NOTICE OF MEETING

**21/0007/LRB (Planning Ref: 20/02264/PP) –
Land South West of Letrualt Farmhouse, Letrualt Farm Lane, Rhu**

**ARGYLL AND BUTE COUNCIL LRB REFERENCE 21/0007/LRB - PLANNING APPLICATION 20/02264/PP
ERECTION OF DWELLING HOUSE AT LAND SOUTH WEST OF LETRUALT FARM, RHU, HELENSBURGH**

Forward Visibility at Bend in Road

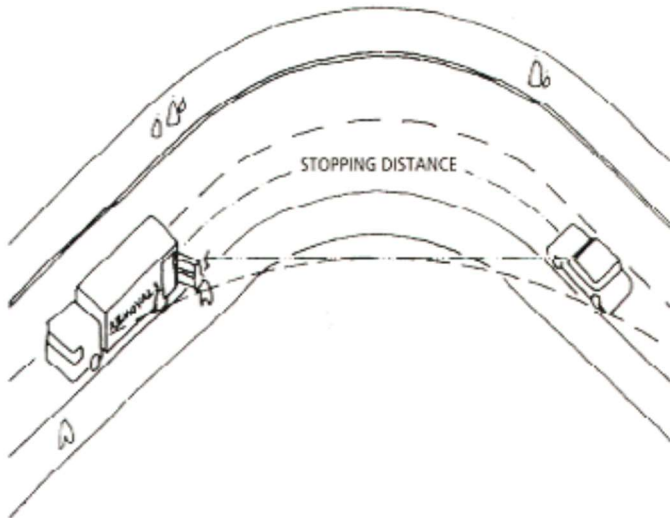
The forwards visibility in accordance with the National Roads Development Guidance cannot be achieved due to the existing geographical constraints.
